P.O.A.D.P. PLAN

CRESTON RIDGE SUBDIVISION

POADP # 533

The City Staff Development Review Committee has reviewed Creston Ridge Subdivision Preliminary Overall Area Development Plan # 533. Please find enclosed a signed copy for your files. Although your plan was accepted, please note the following:

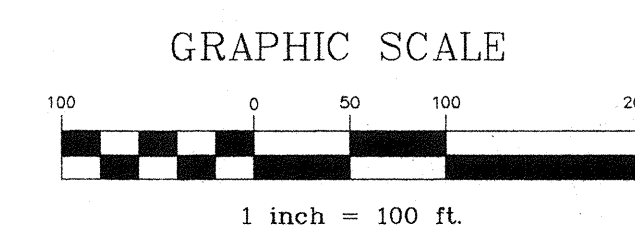
- Judson Road is a Secondary Type A Major Thoroughfare, and will require 83' of ROW.
- Approval of a Manufactured Mobil Home Park Plan will be required, prior to plat approval.
- Drainage Easements will be required and reviewed during the platting process.
- Provisions for a cul-de-sac on Independence Ave. will be required during the platting process.

Show the extension of
Independence Ave or provide
a cul-de-sac

Comments: DRAINAGE EASEMENT WILL BE
REQUIRED AND REVIEWED DURING
THE PLATTING PROCESS
